DATE ~~R~~ Mar.12/03**V2500-D5 NACELLE SERVICE BULLETIN**

This document transmits Revision 1 to Service Bulletin NV2500-78-0170 and
 Revision 1 to the Supplement

Reason for change
 To revise kit contents and
 make related changes to
 text and illustration.

NACELLE - EXHAUST - TRANSLATING SLEEVE AFT LATCH, HEAT SHIELD MODIFICATION/LATCH
ACCESS DOOR HINGE MODIFICATION, THRUST REVERSER

Upper Translating Sleeve Latch Heat Shield Installation
Figure 1 (Sheet 2)

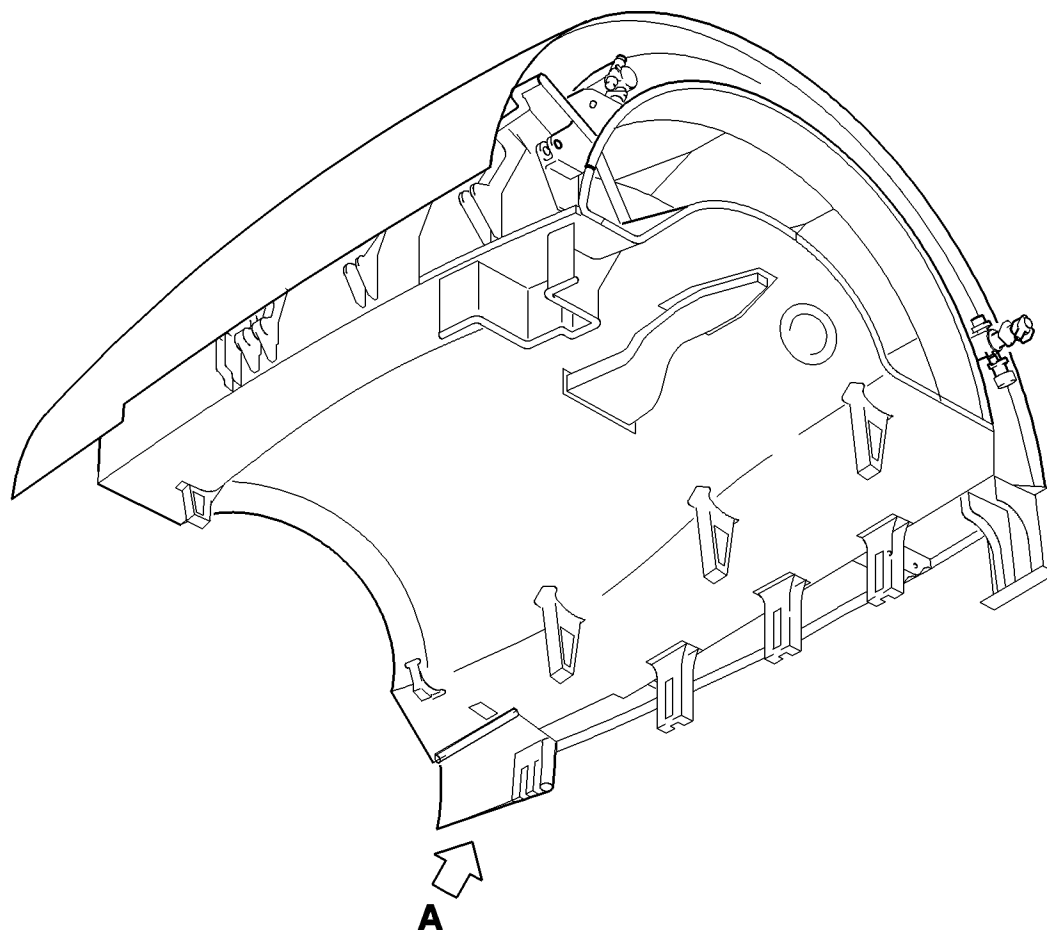
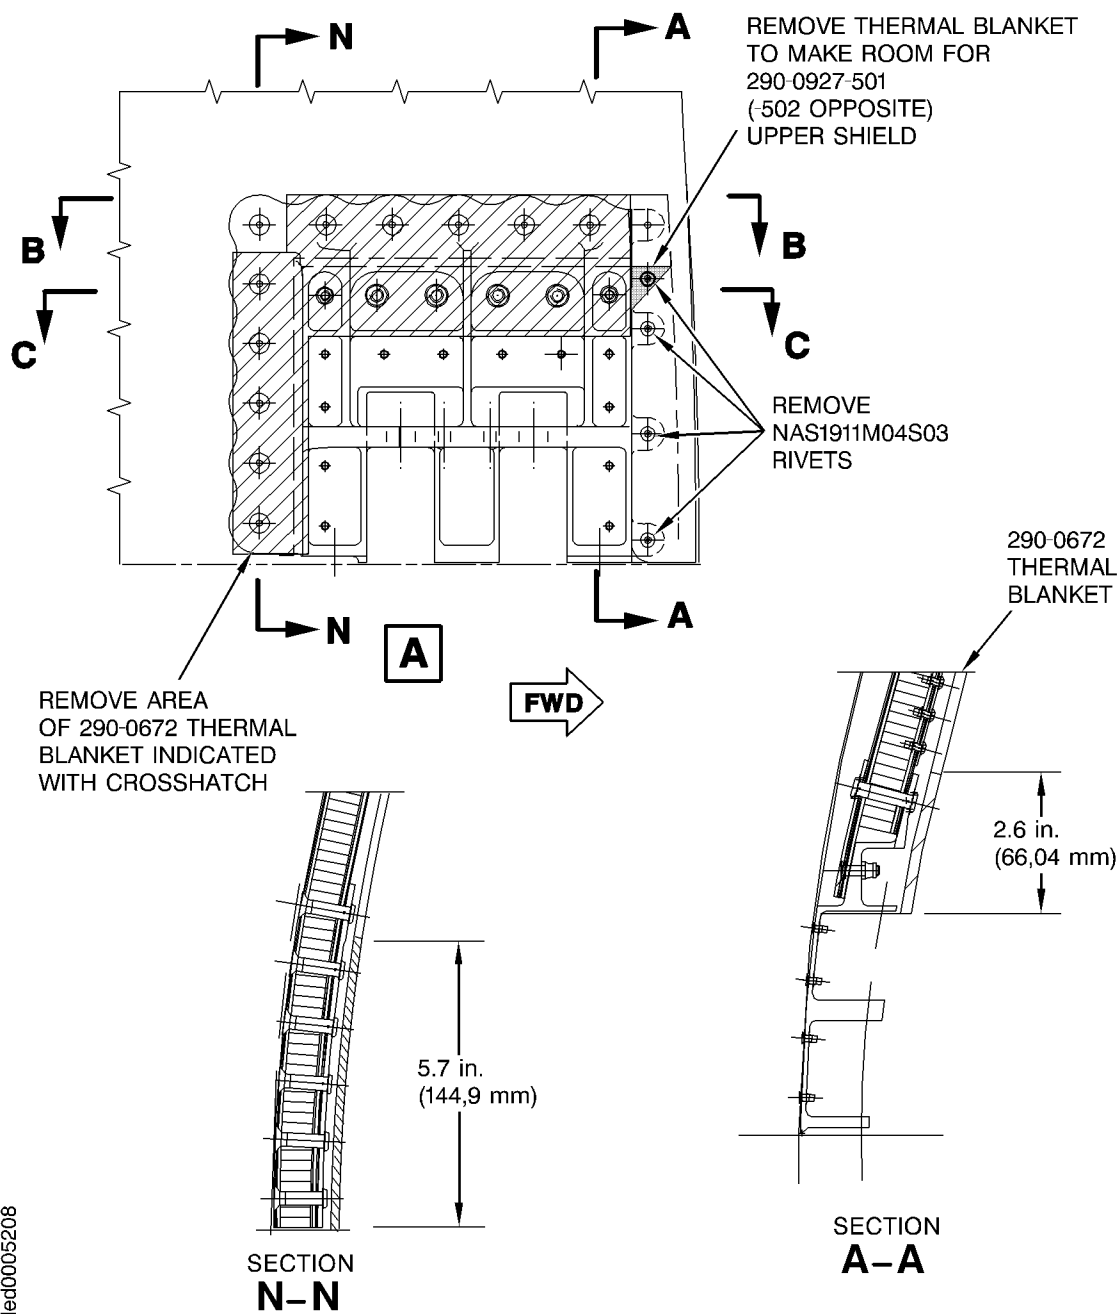
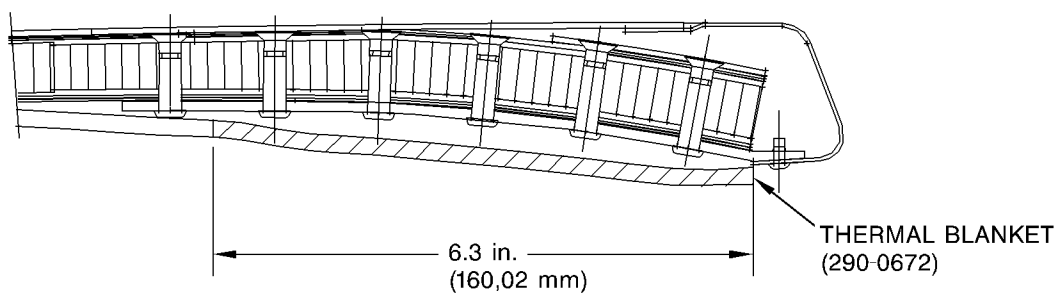
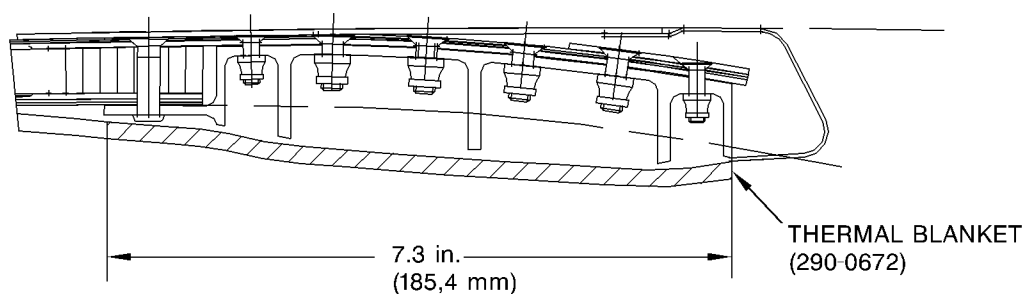
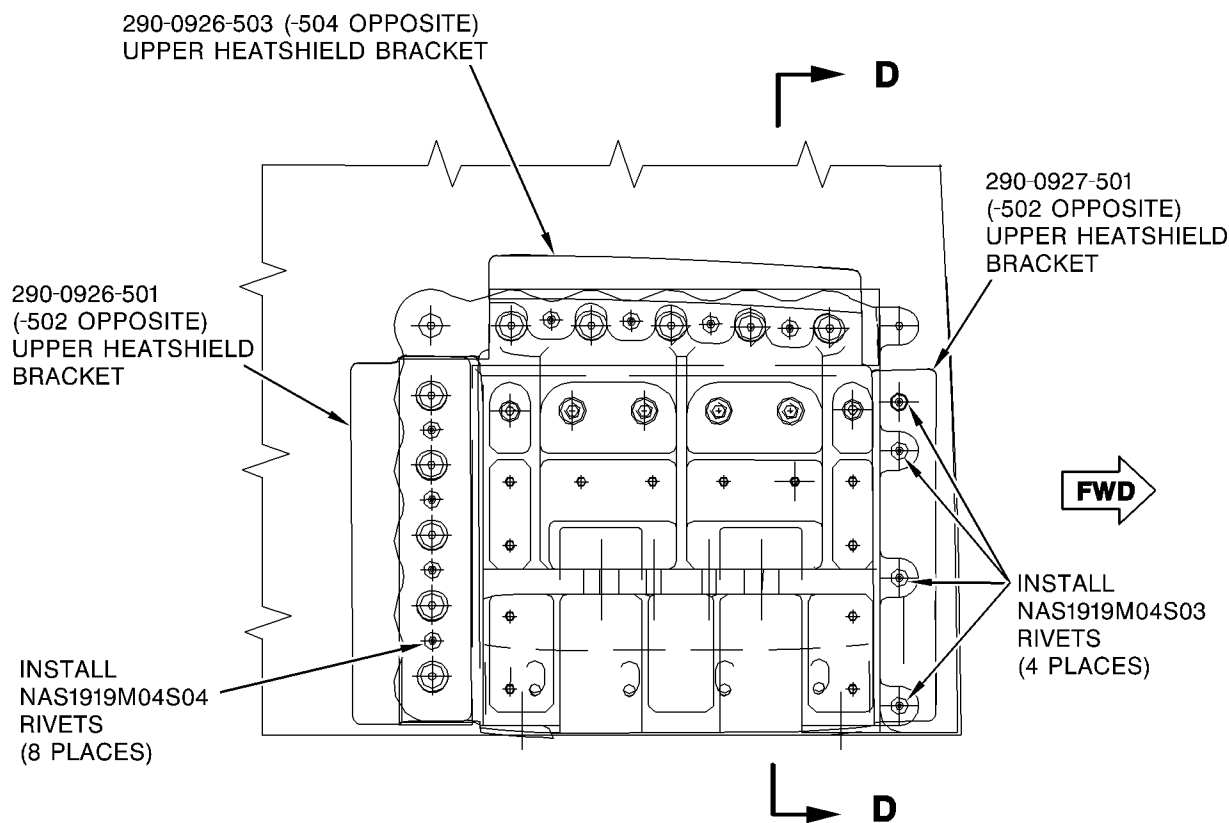
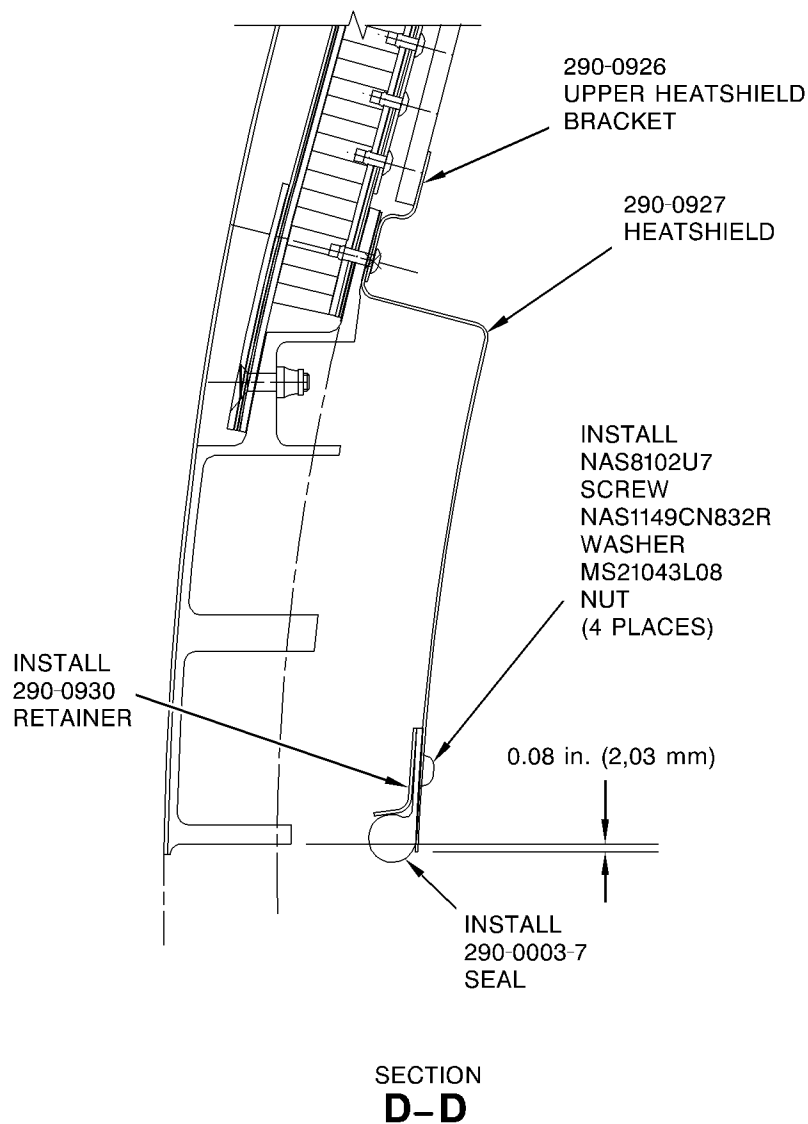
A. Modify the Upper Translating Sleeve Heat Shield. Refer to Figure 1.

- (1) Extend the translating sleeves to the deployed position. Refer to the MD-90 Aircraft Maintenance Manual, Chapter 78-32-00, Page Block 201.
- (2) Remove material from the upper translating sleeve thermal blanket to make room for the new seals and support brackets.
- (3) Remove four rivets from the 290-0528 deflector.
- (4) Install the 290-0003-7 seal and 290-0930-501 retainer on the 290-0927-501 (-502) heat shield with NAS8102U7 screws, NAS1149CN832R washers, and MS30142L08 nuts. Do not torque the nuts at this time.
- (5) Put the 290-0927-501 (-502) heat shield and the 290-0926-501 (-502) and 290-0926-502 (-504) support brackets into position on the translating sleeve.

- (6) Match drill the four holes from the 290-0528 deflector into the 290-0927-501 (-502) heat shield.
- (7) Match drill the eight pilot holes from the 290-0926-501 (-501) and 290-0926-503 (-504) support brackets through the 290-0927-501 (-502) heat shield, the latch housing, and the inner skin of the bond panel.

- (9) Install the 290-0927-501 (-502) heat shield and support brackets 290-0926-501 (-502) and 290-0926-503 (-504) on the translating sleeve with eight NAS1919M04S04 rivets and four NAS1919M04S03 rivets. Wet install the rivets with primer mix.

- (11) Apply sealant (CoMat 08-030) to the cut edges of the thermal blanket and the area between the thermal blanket and the support brackets to make a heat barrier.
